SERVICE BULLETIN

ENGINE - DIFFUSER AND COMBUSTION GROUP - INTRODUCE A NEW NO.4 BEARING COMPARTMENT GASKET - CATEGORY CODE 6 - MOD.ENG-72-0065

V2500-ENG-72-0065

Before and after views of configuration change that affects the No.4 bearing compartment gasket
Fig.1

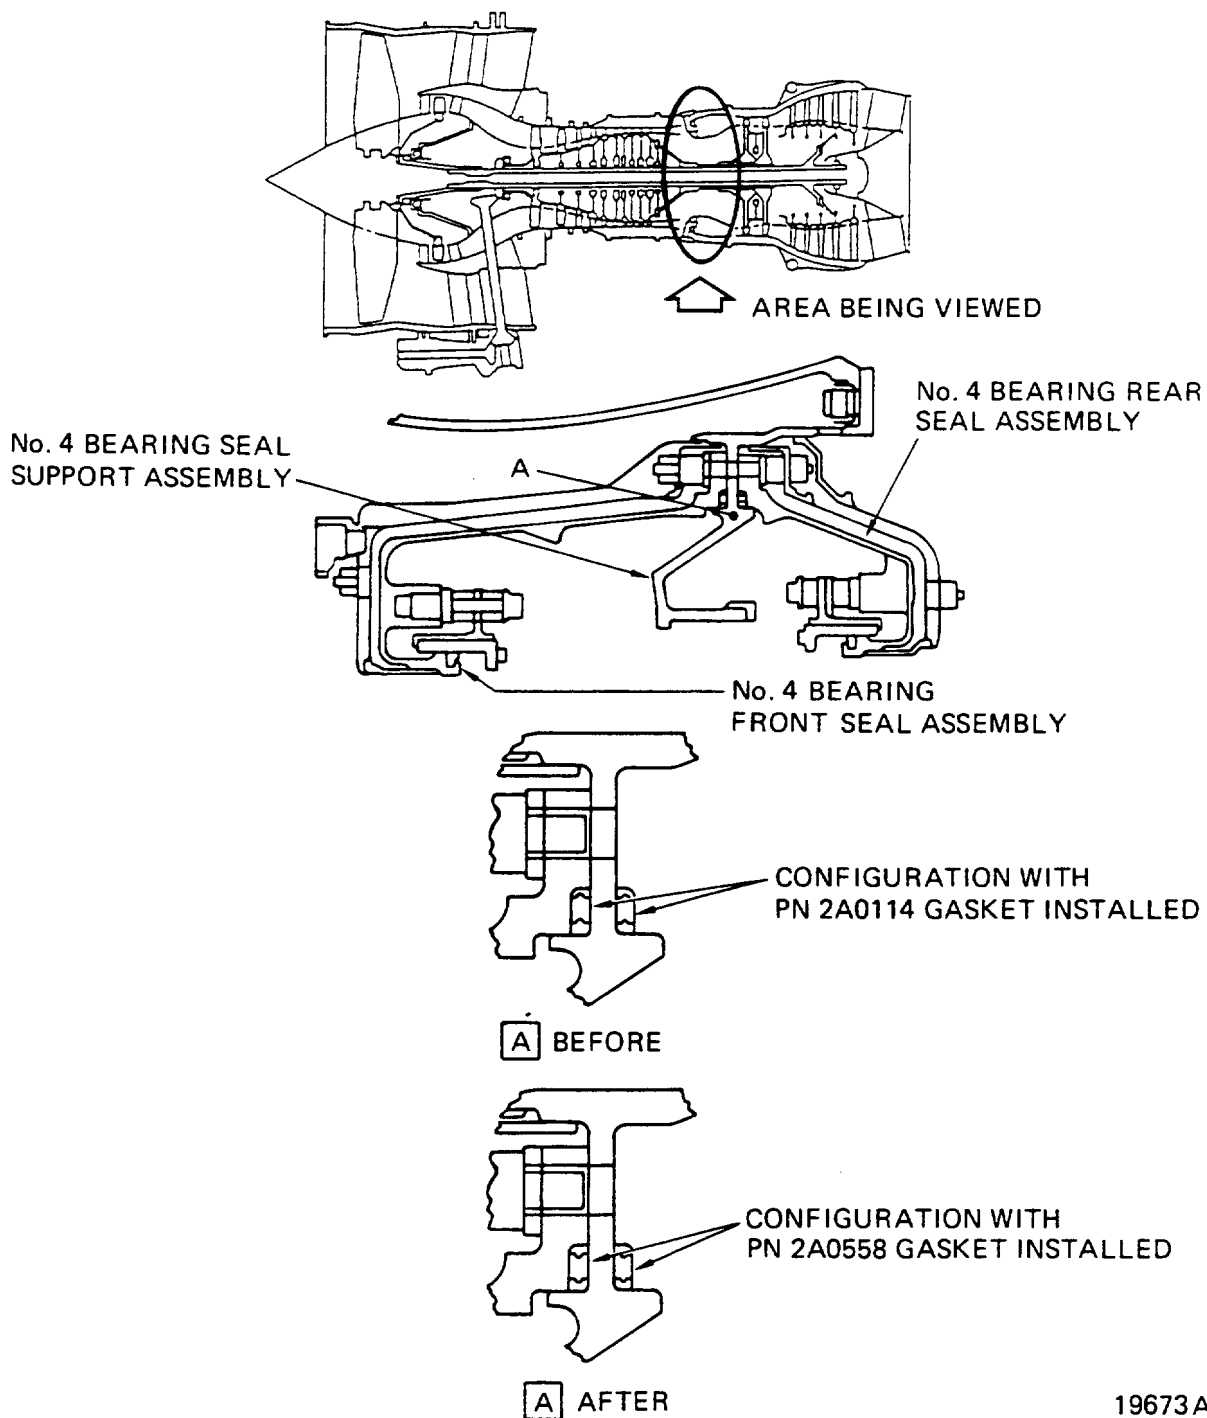
- (1) To prevent a gasket pinch at assembly, the new gasket is piloted on the inner diameter. Refer to Figure 1.

Location of No.4 bearing front compartment gasket
Fig.2

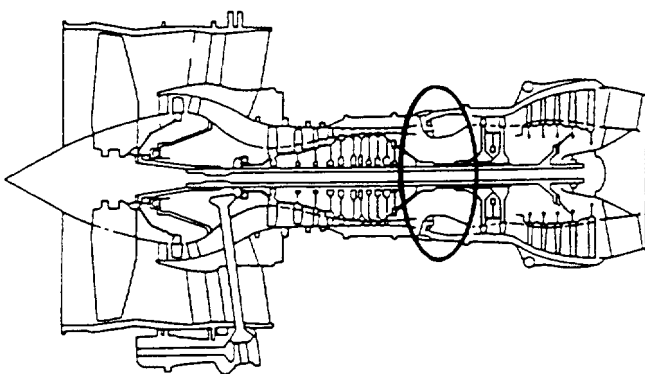
- (1) Install the 2A0558 No.4 Bearing Front Compartment Gasket (1 off) by the approved procedure in Reference (1), Chapter/Section 72-42-30, Assembly. Refer to Figure 2.
- (2) Install the 2A0558 No.4 Bearing Rear Compartment Gasket 1 off by the approved procedure in Reference (1), Chapter Section 72-40-00 Assembly-03. Refer to Figure 3.

Location of No.4 bearing rear compartment gasket
Fig.3

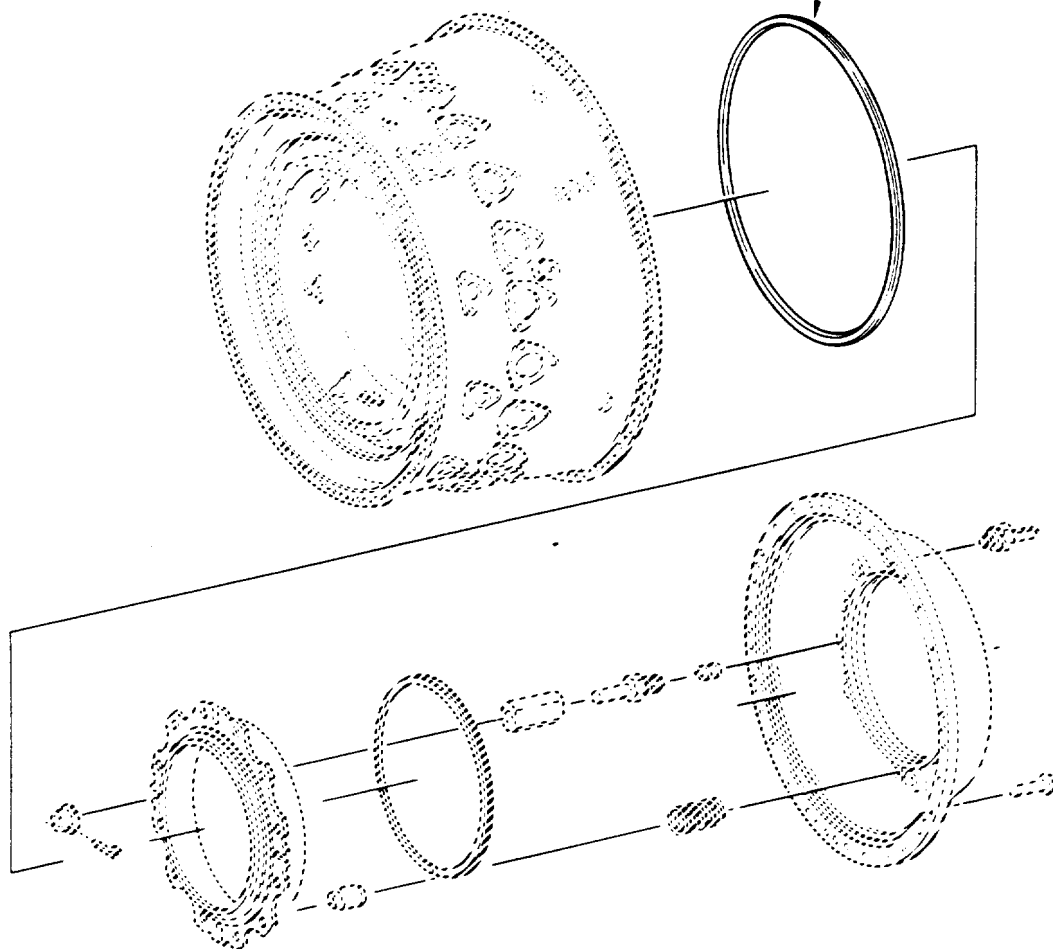
REMOVE THE PN 2A0114
GASKET AND INSTALL THE
PN 2A0558 GASKET (1 Off)
